FINAL DRAINAGE REPORT

FALCON MEADOWS AT BENT GRASS

FILING NO. 2

PCD Filing No.: SF2134

Inlet DP 24 - Existing At-Grade Inlet

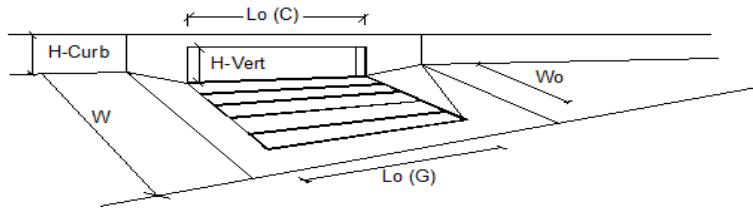
Review 1 comment:
Please discuss in the narrative the flow bypassing this inlet. Where is this developed flow being conveyed to and treated.

Narrative revised to reflect discussion of flow bypassing Inlet @ DP 24 in Basin E-4

Engineering Profile - Mainline Storm Sys (FM Filing 2 System A.stsw)

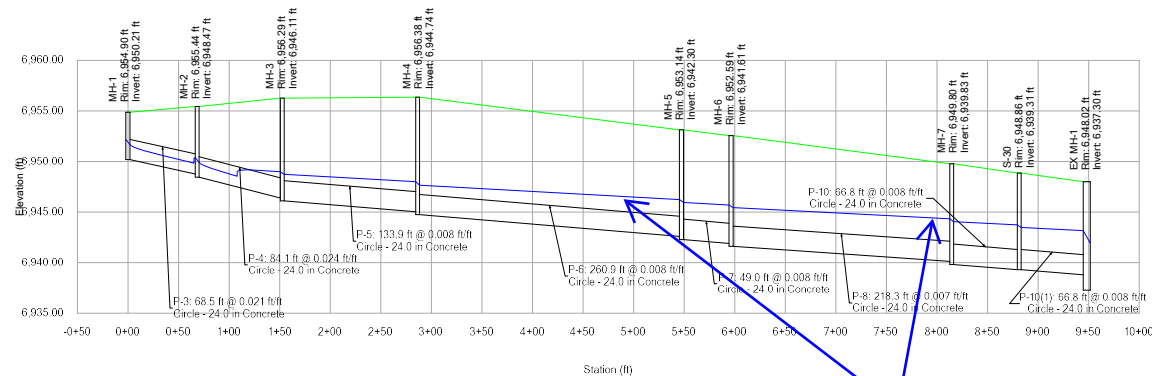
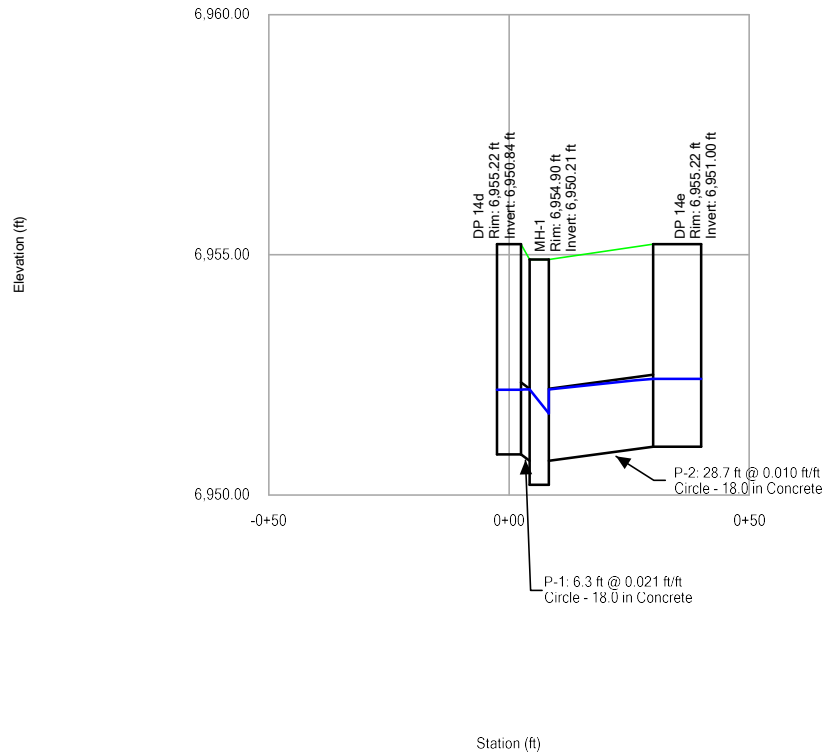
Per ECM 3.3.1.D pipes shall be design free of pressure heads except for short runs where it cannot be avoided. It does not appear that this criteria is met. please revise the storm pipes (p5-p10) as necessary

Per email from Daniel Torres @ 02.08.2022, watertight joints will be required on the CDs. Verbiage to this effect has been added within the IX. Storm Sewer System section of the narrative.

Engineering Profile - Ex Mainline (FM Filing 2 System A.stsw)

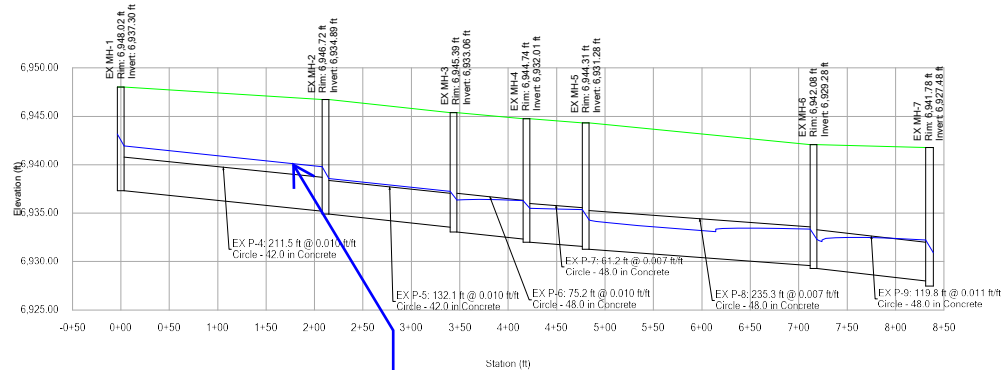
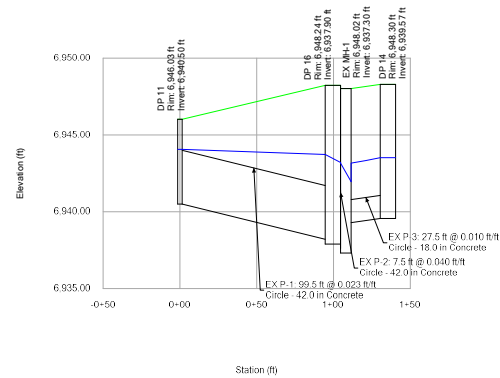
This does not meet ECM 3.3.1.D. Please identify whether watertight joints were used at the existing pipe. The situation with this existing pipe run will be discussed with the engineering manager/ECM administrator. I will relay any comments/direction provided.

Per email from Daniel Torres @ 02.08.2022, watertight joints will be required on the CDs. Verbiage to this effect has been added within the IX. Storm Sewer System section of the narrative.

Basin ID: WQCV Pond - North

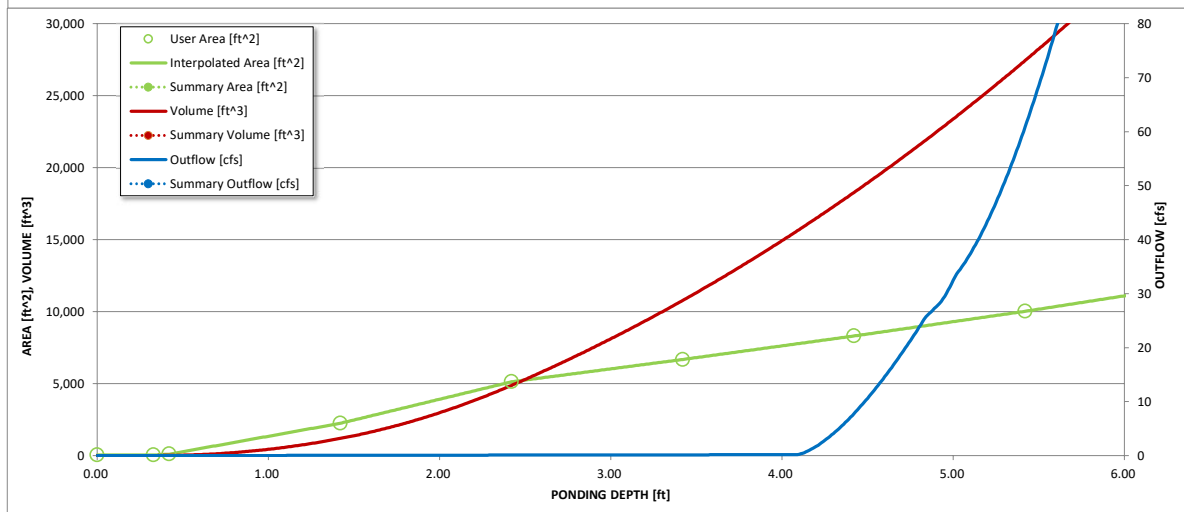
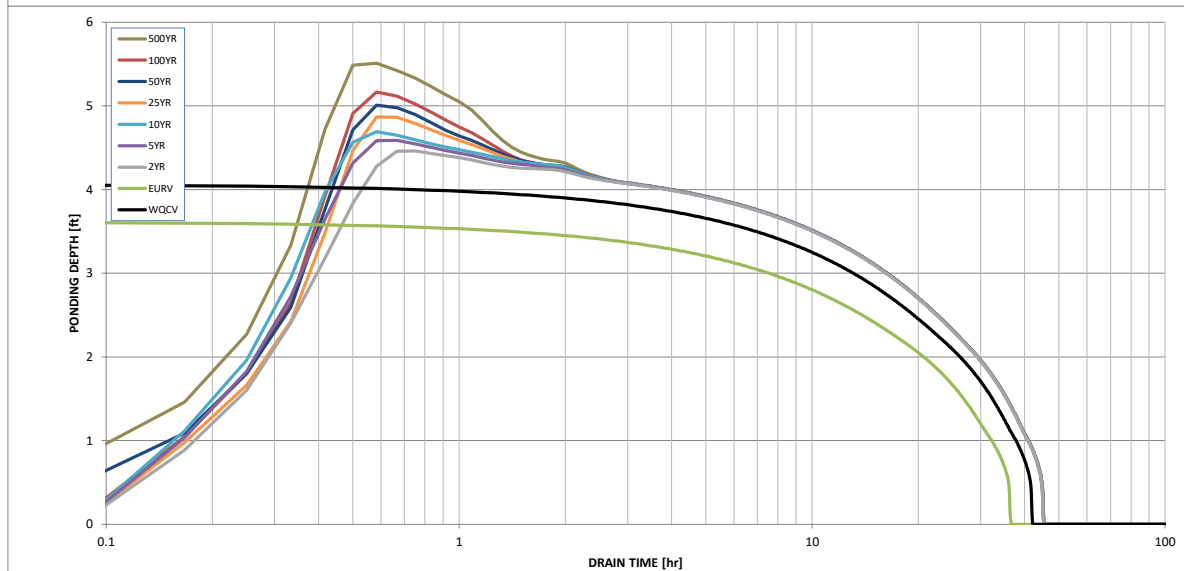
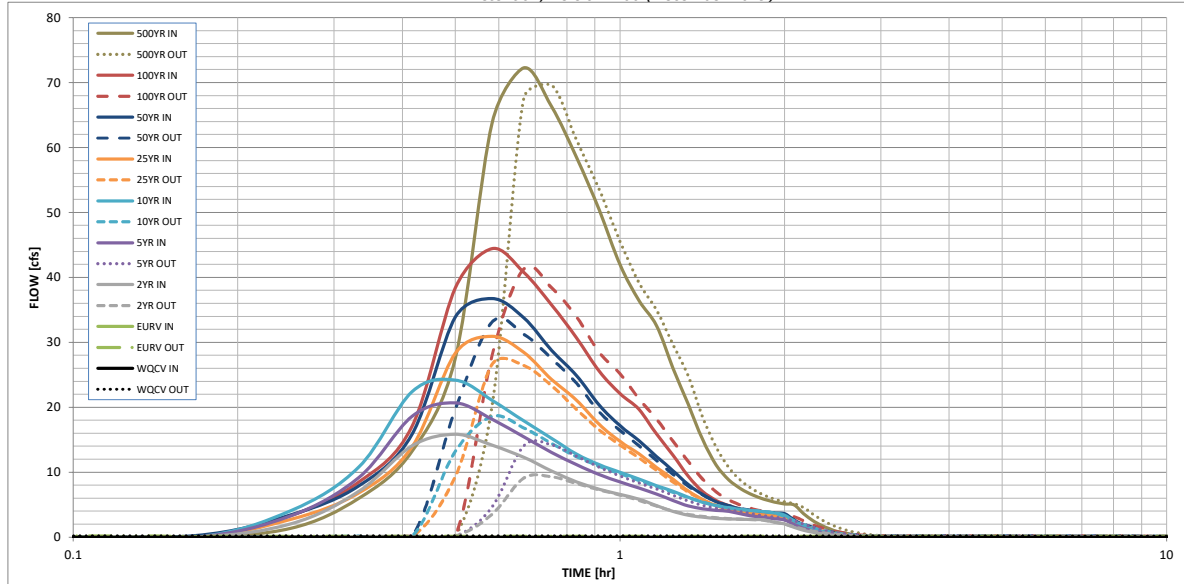
Why was no data inputted for the existing condition??
There are Q's calc'd for existing condition on pdf pg 43 above...

Revised to reflect existing condition
